# Development of part of System Six C70 south of the Maidens. Bunbury endowment land Part of Lot 626, and Parts of Lots 301 - 4

# City of Bunbury Homeswest

Environmental Protection Authority Perth, Western Australia Bulletin 789 September 1995

Figure 4. Proponents' original options (Source: Hart, Simpson and Associates, 1994).

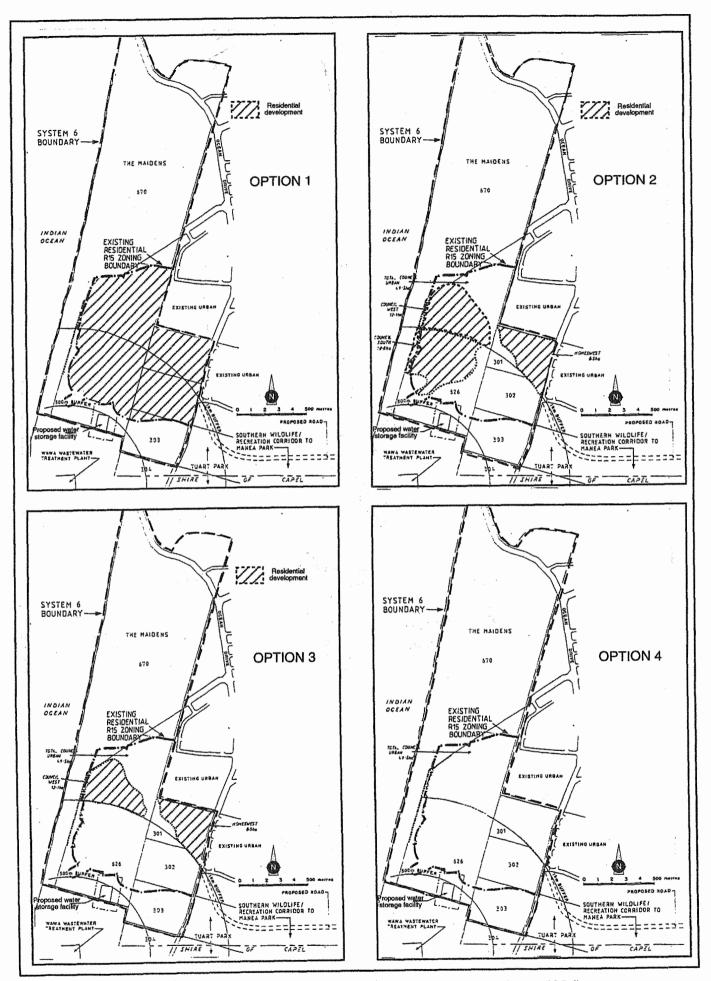
The proponents considered that Option 2 was the most appropriate, however, the proponents understood that this Option could not be implemented at this stage because of the Water Authority of Western Australia's requirement for a 1,000 metre buffer around the Waste Water Treatment Plant. Option 3 was the proponents' second choice as it could be implemented immediately without compromising Option 2. Options 2 and 3 are the basis of the proposed development, with Option 2 to proceed only if a reduced buffer around the Waste Water Treatment Plant can be agreed upon (Hart, Simpson and Associates, 1994).

Figure 5. Development scenarios overlain on vegetation of the study area (Source: Hart, Simpson and Associates, 1994).

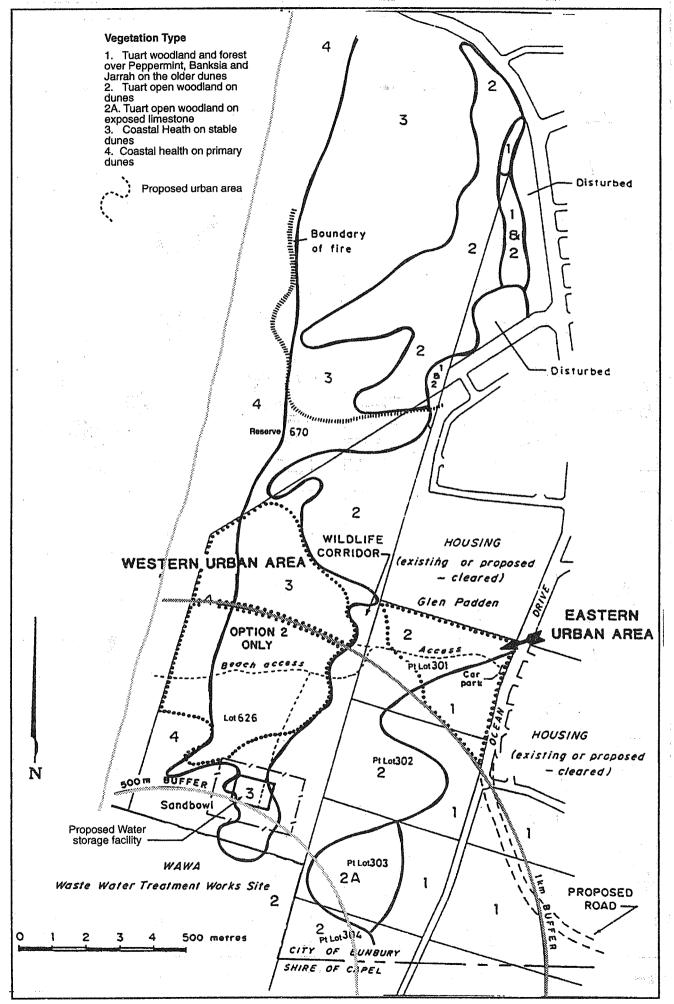
According to the Water Authority of Western Australia (1994; submission on Consultative Environmental Review), the buffer lines described in the Consultative Environmental Review (see Figure 5) are drawn from a radius using the middle of the plant as its centre. It is usual that buffers are drawn from the edge of the inner plant boundary fence. This would align the 500 metre buffer with the western projection of the boundary between lots 302 and 303. A similar adjustment is required to the 1 kilometre buffer.

3-1 To protect the flora, fauna, conservation and landscape values of the South Bunbury Coastal Land (System Six recommendation C70), the proponent shall not permit residential development in the area described as the 'Eastern Urban Area', Part Lot 301, as indicated in Figure 5 of EPA Bulletin 789 (copy attached).
